Balboa Park Central Mesa

Precise Plan

Proposed Amendment for
Plaza de Panama, Circulation, and a Parking Structure

April 5, 2012
Sixth Draft

Recovered and Converted Open Public Park Land

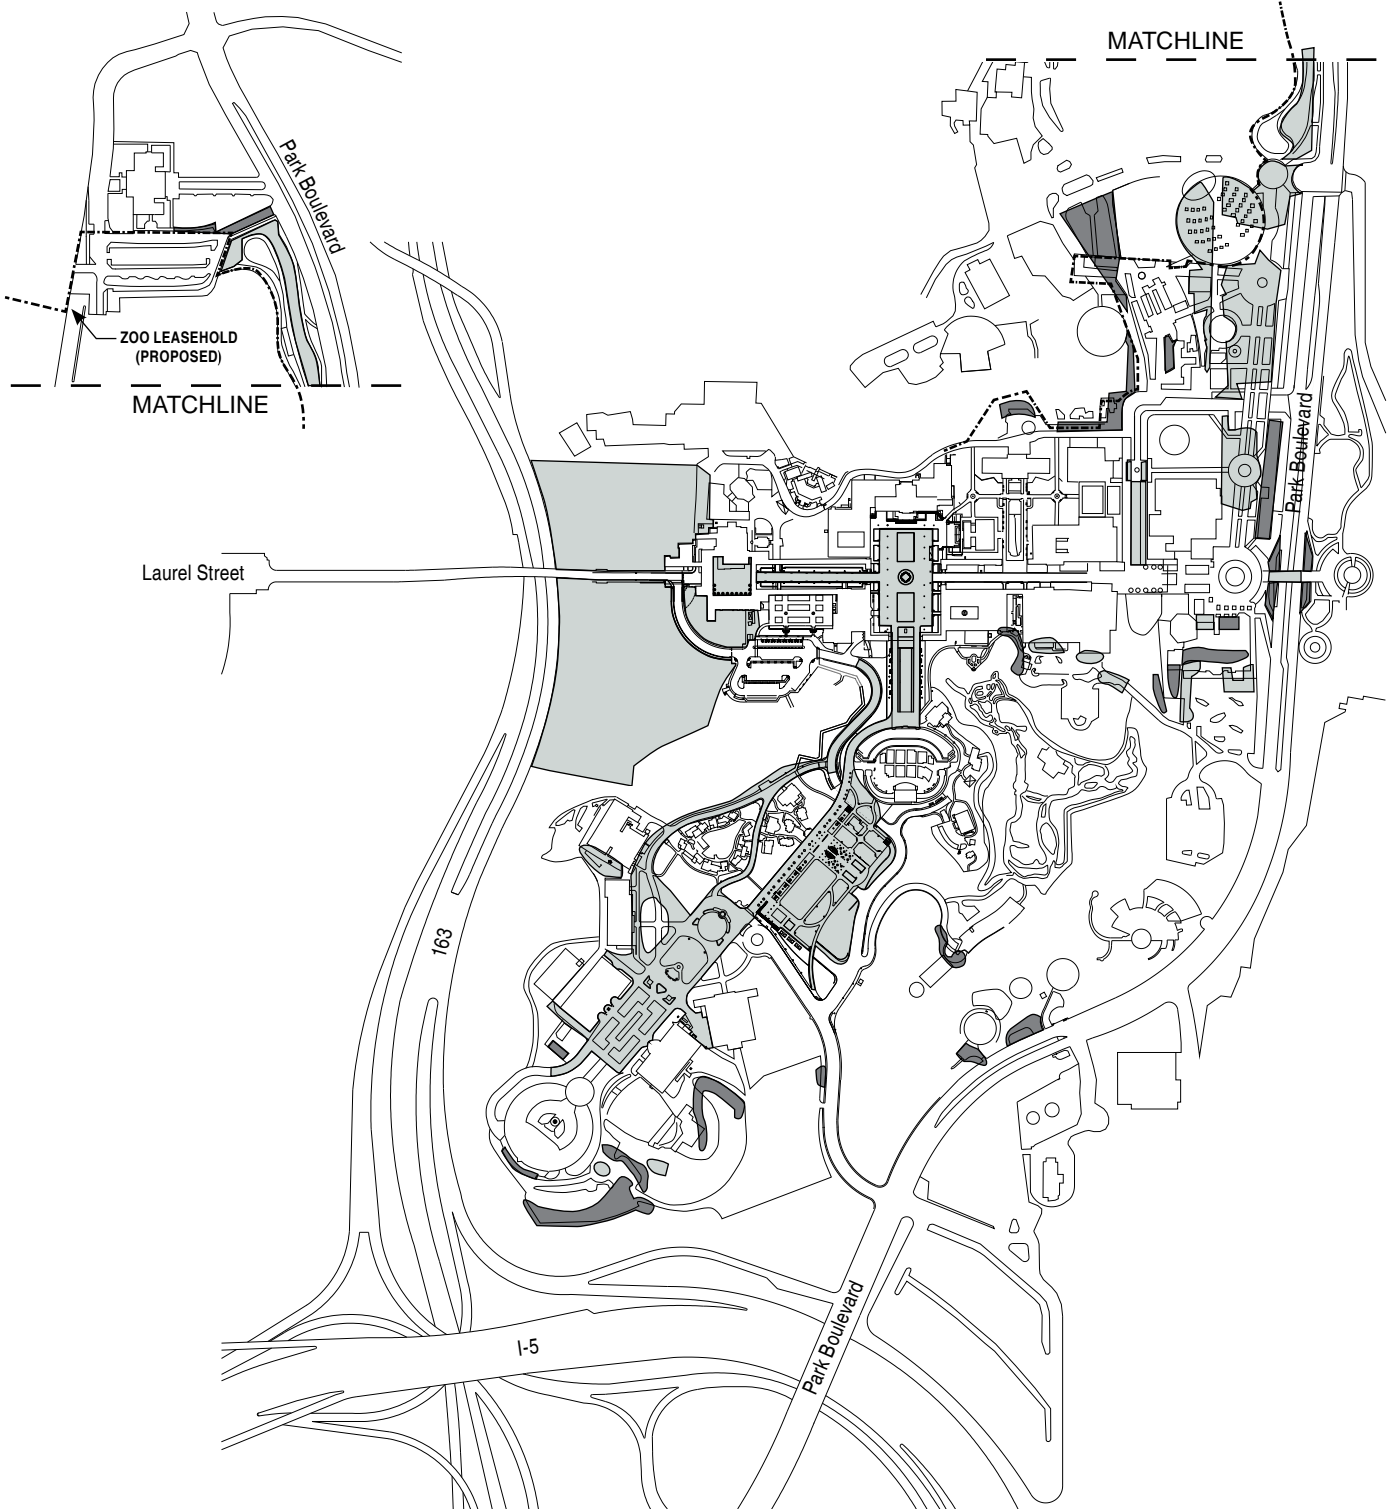
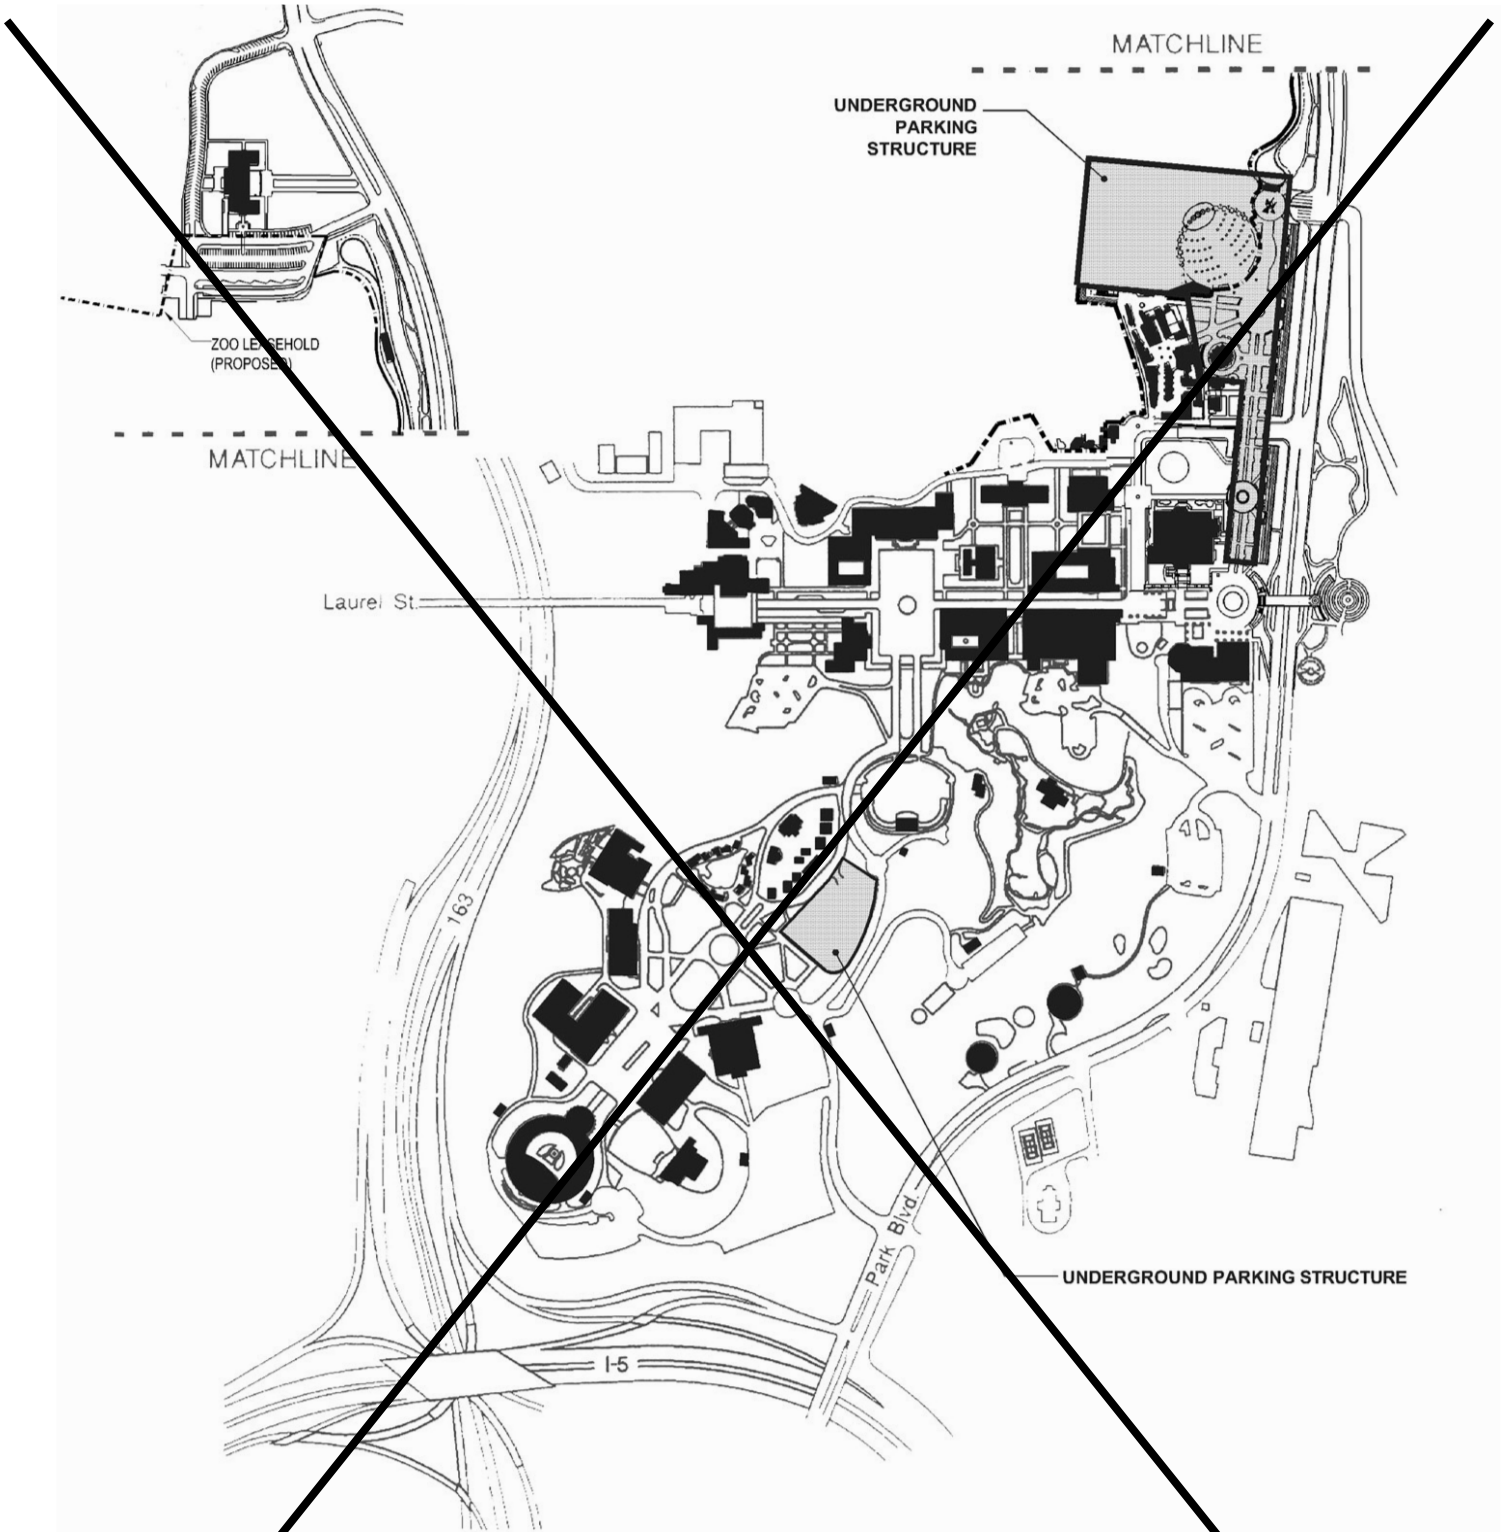
- Open Public Park Land Recovered from other Uses – **32 33** acres
- Open Public Park Land Converted to other Uses – **27 5** acres

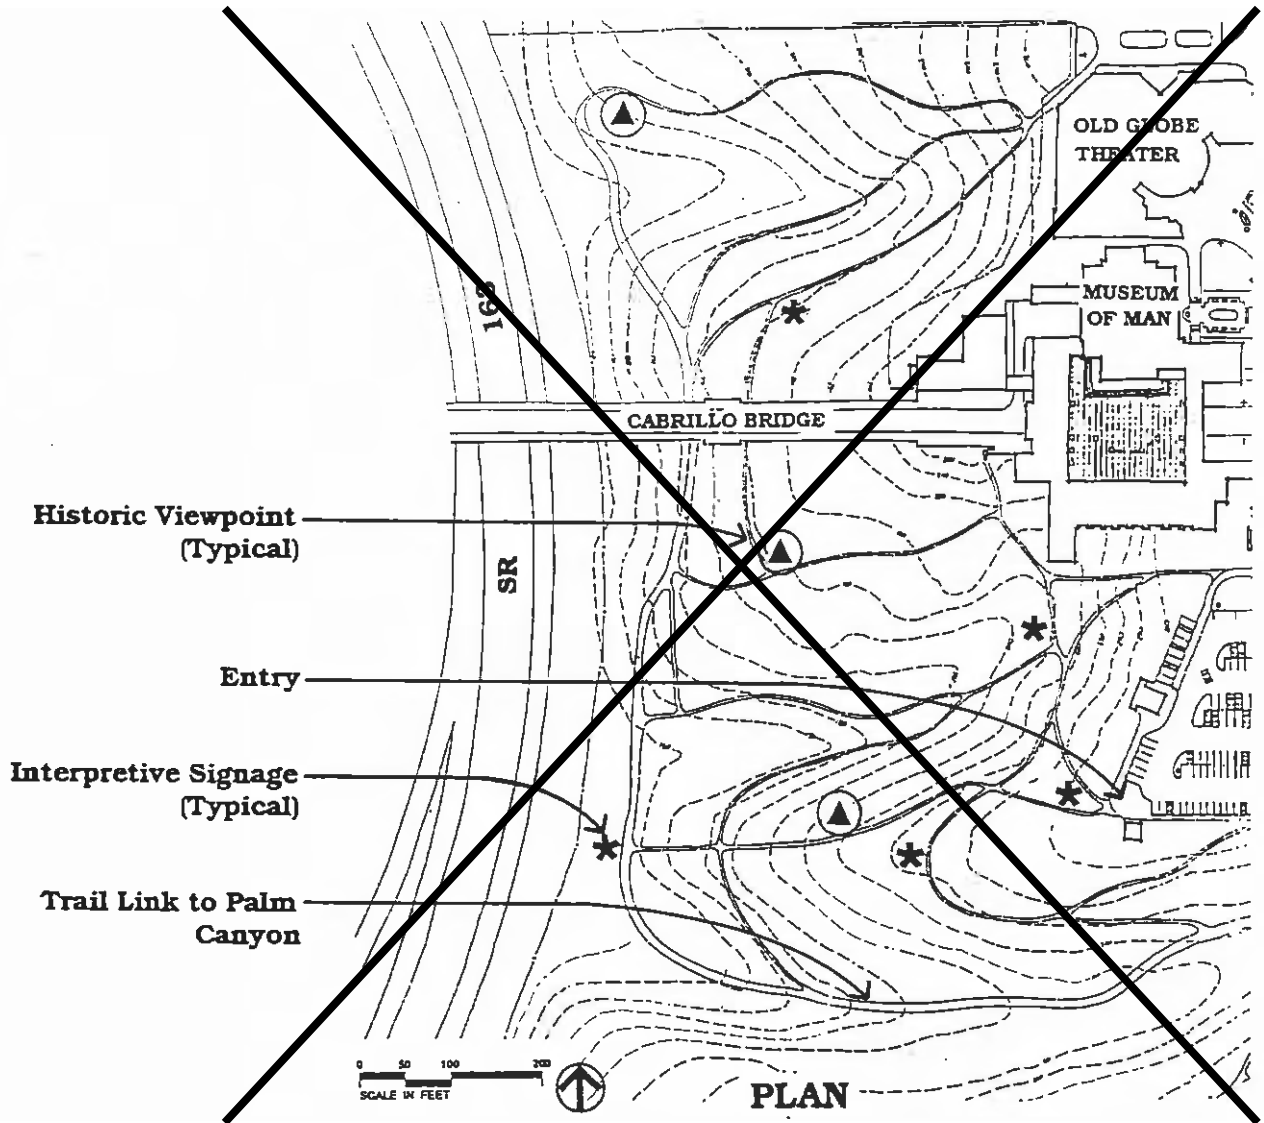
Modify the West Prado in order to ~~provide for automobile turnout lanes while re-establishing~~ re-establish as much of the historical character of this processional space as possible.

- Replace asphalt with decorative concrete paving to ~~match~~ complement existing East Prado paving surface.
- Install a pedestrian drop-off lane on each side of the vehicular circulation lanes ~~as shown on the plan~~.

PLAZA DE PANAMA
PLAN

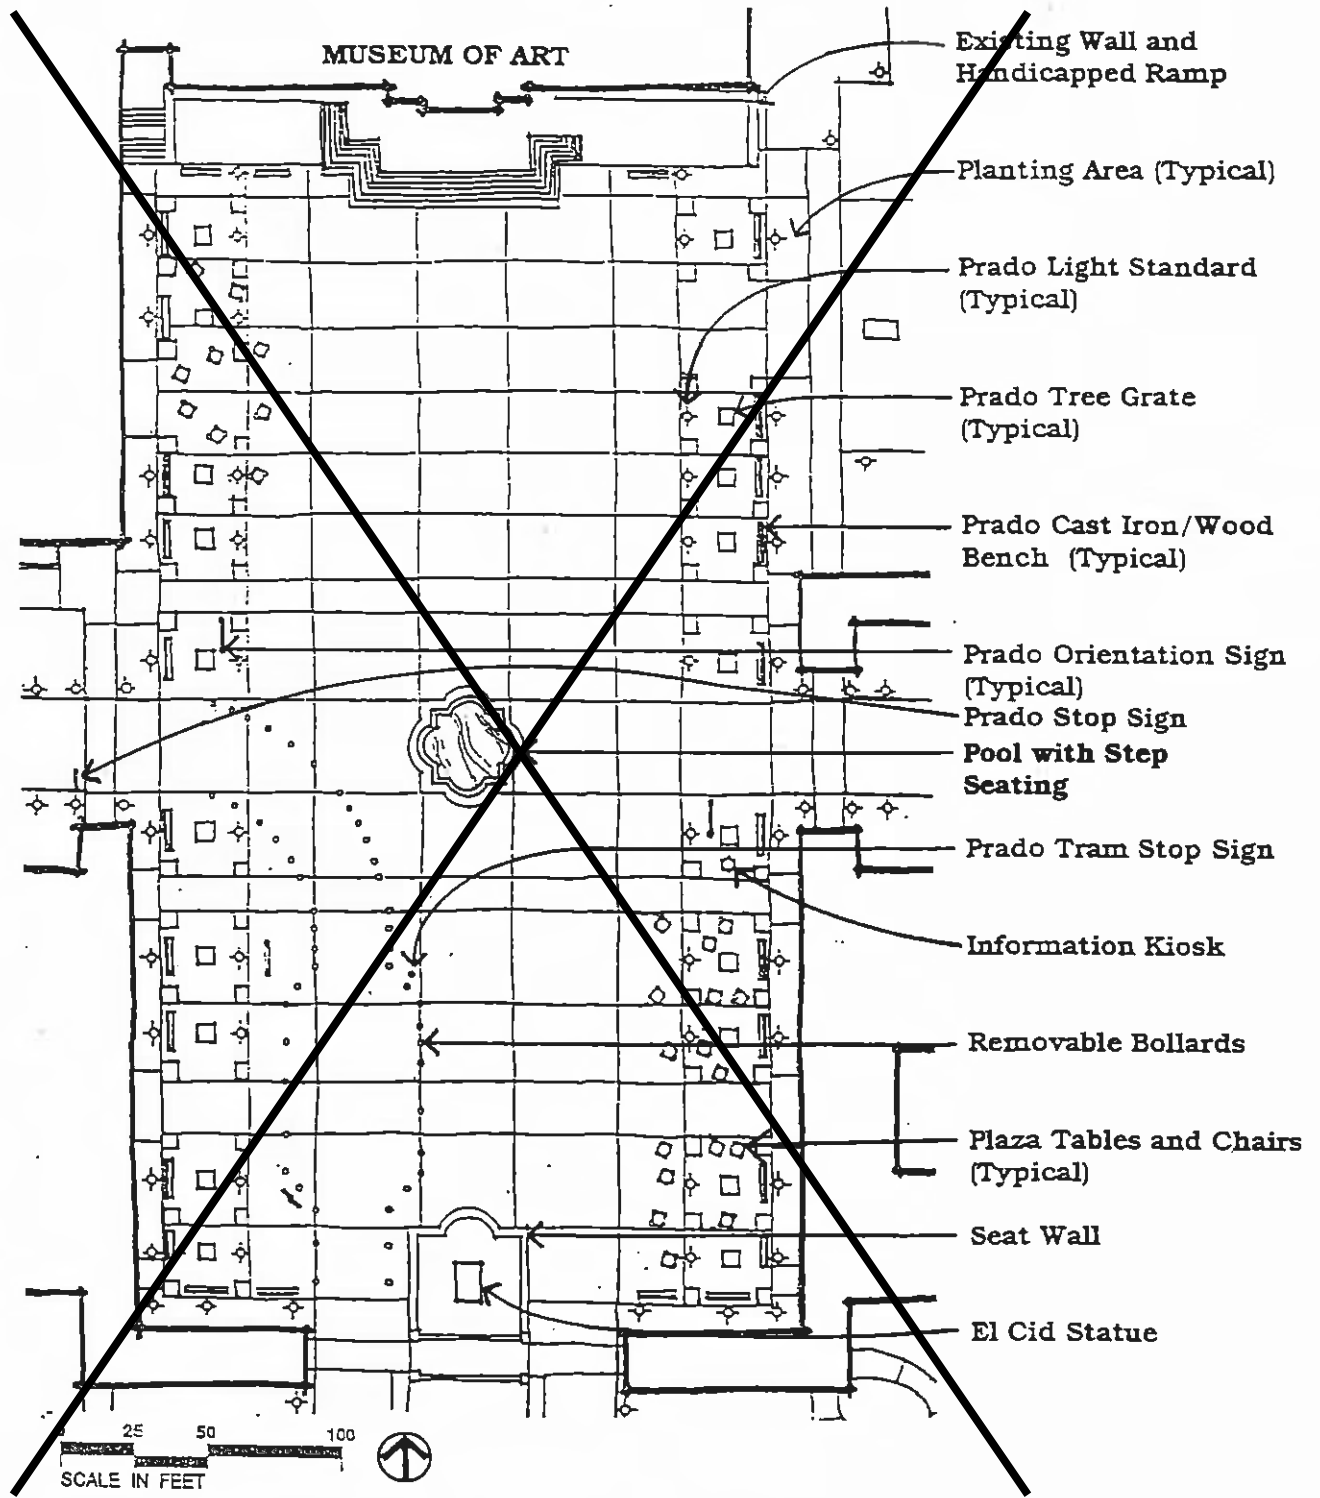
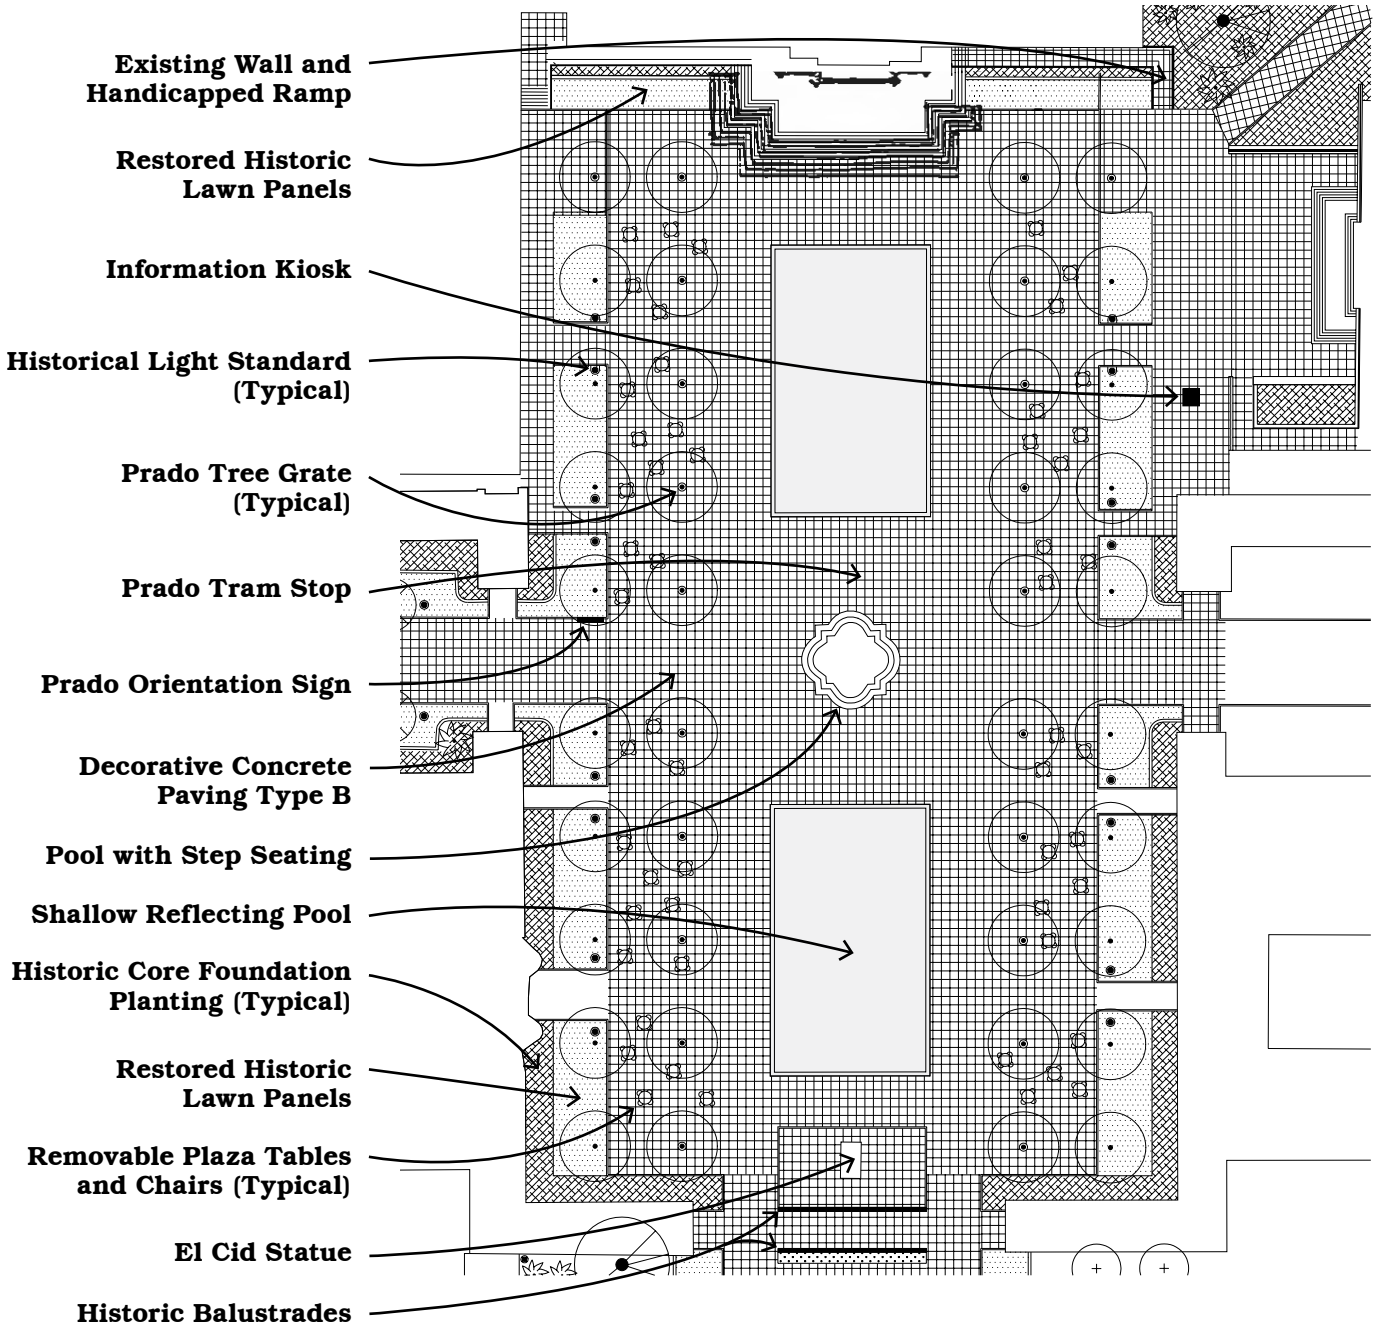
- Place benches along the periphery of the plaza as shown.
- Plant bosques of ~~queen palms~~ Plaza de Panama-specific trees at the margins of the plaza.

- Accent the central axial crossing point of the Prado by placing a Spanish Colonial pool in the center of the plaza flanked by shallow reflecting pools to the north and south. ~~Two levels of monumental steps will form the rise to the central pool. These should not exceed 30" in height and be surrounded by a rim that is a minimum of 16" wide to provide seating. Concealed down lights built into the pool steps should be included. Mosaic tiles inside the pool should repeat historic motifs such as the sunburst design found on the tile dome of the California Building. Decorative brass fixtures should also be included inside the pool to support a portable stage deck for special events.~~

- Provide aesthetically pleasing night lighting in the plaza. Features in the Plaza de Panama to highlight will be the trees bosques of palms, the central Spanish Colonial pool, the two reflecting pools, El Cid, and the surrounding arcades and architecture.

- Create two shallow reflecting pools in the plaza, one north and one south of the central Spanish Colonial fountain.
- The pools should have the ability to be deactivated if necessary.
- The depth of the pools should not exceed 1/2” such that when deactivated the surface can be used as part of the plaza space.
- Consider intermittent water jet features to activate the shallow reflecting pools as a play area.
- ~~Locate a seat wall around the statue of El Cid, enclosing seasonal flower beds.~~
- Provide unobtrusive and secure electrical service to support sound and lighting equipment in several areas of the plaza. Provision should also be made for power to be provided to a stage that could be set up over the central fountain.
